API REVIEW

API's Review of Recent USGS Pavillion, Wyoming Reports Show USGS Groundwater Sampling Results Differ From EPA's Results in 2011 Draft Report

Figure 1. Modified after USGS Figure 2, Data Series 718 Report¹

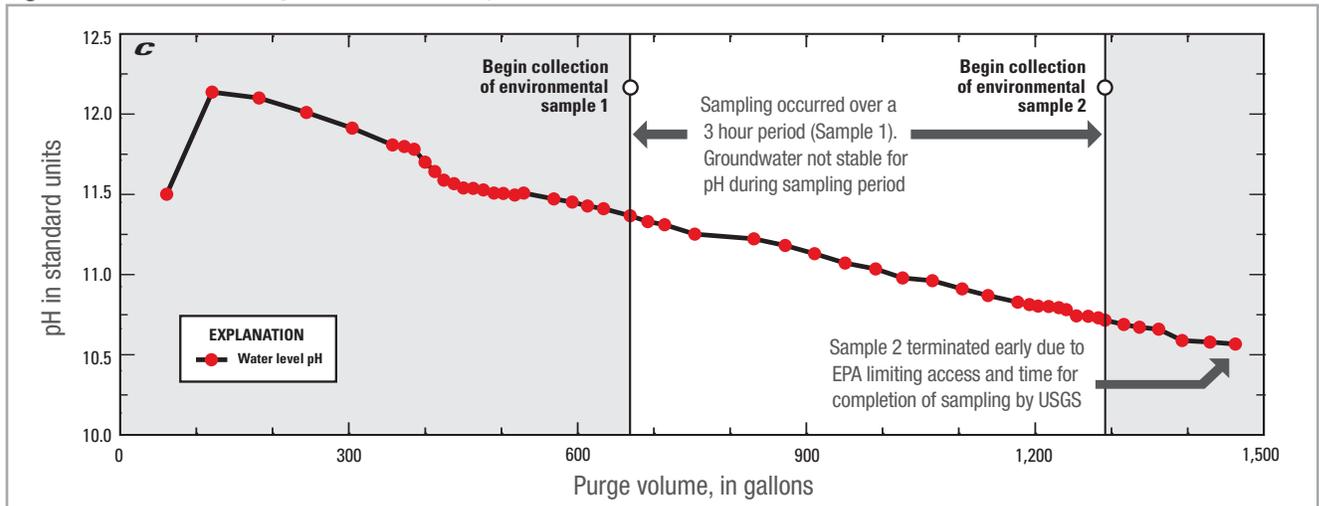
- USGS' SAP² specified a criterion for sampling that required the pH of the groundwater to be stable for sampling. A review of the USGS data presented in the report¹ shows, as depicted in Figure 1, pH stabilization did not occur during sampling, and the graph suggests that well MW-01 is likely still being impacted by high pH cement and/or drilling fluids used during monitoring well drilling or construction.
